## **Technical Service Note 32-10**

**SUBJECT:** Airliner Rear Suspension Clamp Group.

**PRODUCTS:** Cascadia and Western Star 5700 vehicles equipped with an Airliner 40K rear suspension and DA-RT-40.0 rear axle.

Illustration 1.

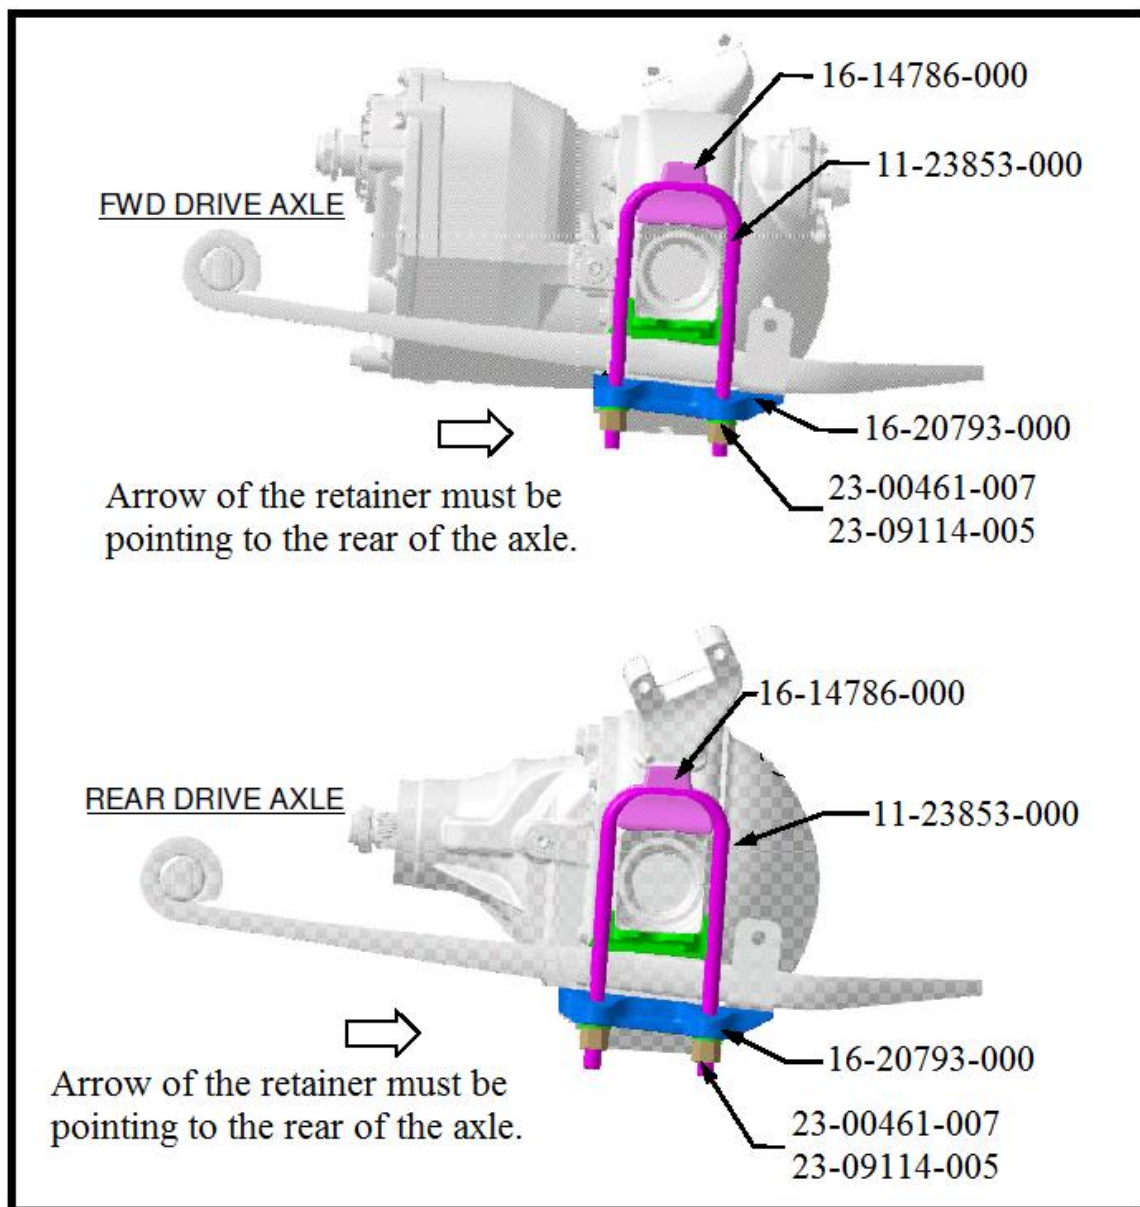
The incorrect Airliner Rear Suspension clamp group top pads and lower retainers will be removed and replaced with the correct parts. The ubolts, high nuts and washers will be replaced.

Reference Illustration 1.

- 3) Remove and discard the existing ubolts, high nuts and washers.
- 4) On the forward drive axle keep and reuse the existing top pad and replace the lower retainer with P/N 16-20793-000.  
Install the lower retainer with the arrow pointing to the rear.
- 5) On the rear drive axle remove and replace the top pad with P/N 16-14786-000.  
Remove and replace the lower retainer with P/N 16-20793-000.
- 6) Install new ubolts, washers and high nuts. Tighten per Fig 1.

**Fig. 1, Tightening Pattern for U-Bolt High Nuts**

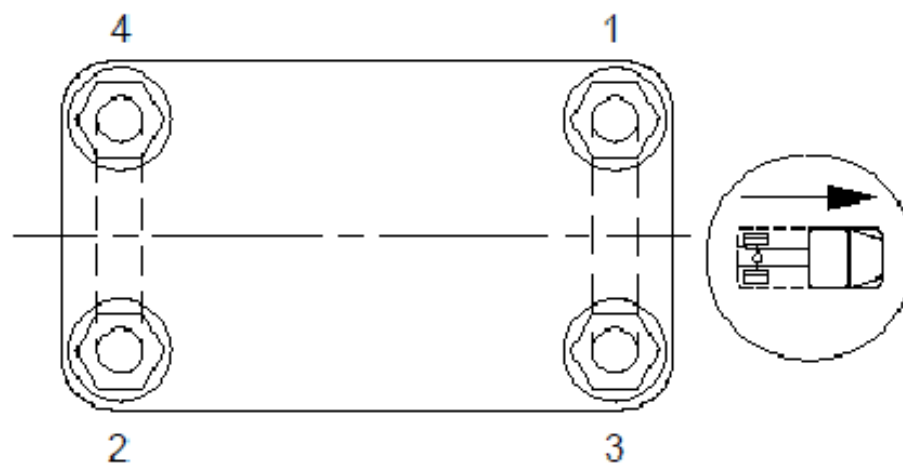
**Axle U-Bolt High Nuts**  
Tighten in a diagonal pattern as shown in **Fig. 1**.

| 7/8–14 | Stage 1: Hand-tighten      |
|        | Stage 2: 60 ft-lbs         |
|        | Stage 3: 200 ft-lbs        |
|        | Stage 4: 420 to 500 ft-lbs |
